# RUSSIAN MARITIME REGISTER OF SHIPPING

**CIRCULAR LETTER**

**No. 314-42-1474c**

amendments to the Rules for the Classification and Construction of Sea-Going Ships in connection with implementation of IACS UR S33 (Rev.2 Dec 2019 and Rev.3 Feb 2020)

Fig. 3.3.2  
Upper flange longitudinal structural members."

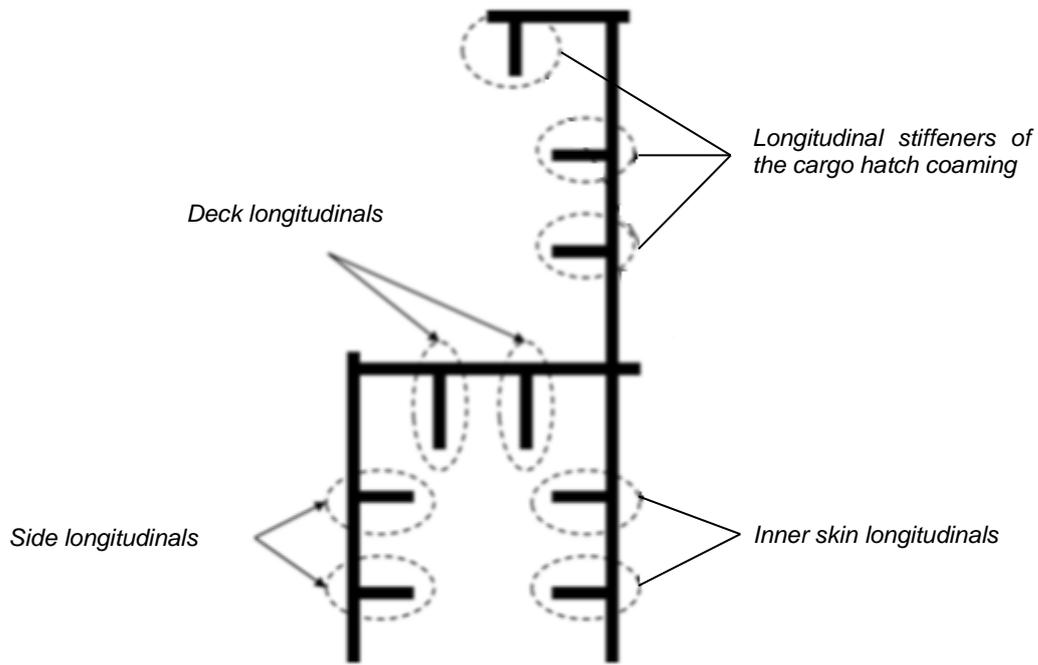
- 4 **New para 3.3.2** is introduced reading as follows:

**3.3.2** Non-destructive testing of welded joints of hull structures of container ships manufactured of extremely thick steel plates.

Ultrasonic testing (UT) in compliance with 3.2.6 shall be carried out on all block-to-block butt joints of all upper flange longitudinal structural members in the cargo hold region, including the topmost strakes of the inner hull/bulkhead, the sheer strake, main deck, coaming plate, coaming top plate, and all attached longitudinal stiffeners (refer to Fig. 3.3.2).

- Notes: 1. Acceptance criteria of UT shall be in accordance with 3.4.6 and/or recognized standards.  
2. The acceptance criteria may be adjusted under consideration of the appertaining brittle crack initiation prevention procedure, and where this is more severe than that found in the Rules and standards, the acceptance criteria shall be amended accordingly to a more severe sensitivity.
